Replacement System Variance Request

SUBJECT: Approval Replacement System Variance Request, Glazier property, Pleasant Hill Road, Augusta

PLEASANT HILL ROAD  
SUBSURFACE WASTEWATER DISPOSAL PLAN  
HOME

DISPOSAL AREA CROSS SECTION

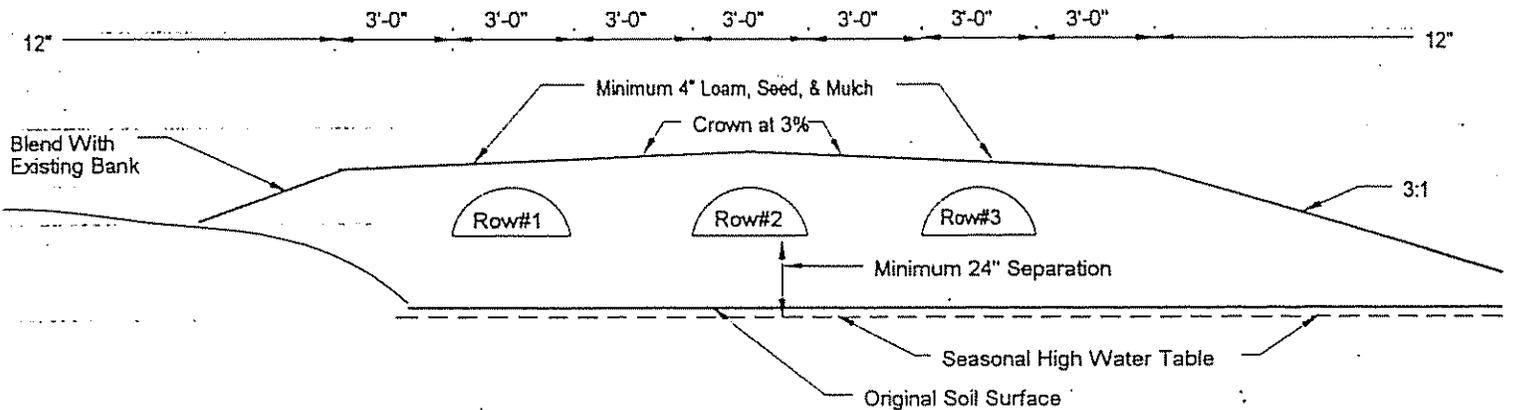
1. A permit for system installation is to be obtained from the Local Plumbing Inspector in advance of the start of system construction.
2. The system is to be installed in accordance with the submitted and approved system design. However, one additional item is to be noted - the fill material is to be mixed into a minimum of 4 inches of original soil as a transitional zone prior to placing the remainder of the fill. Any other alterations to the design which may be required at the time of construction must not be made until the system designer has been notified.
3. Extreme caution must be taken to avoid compaction of the surface layer prior to installing the chambers.
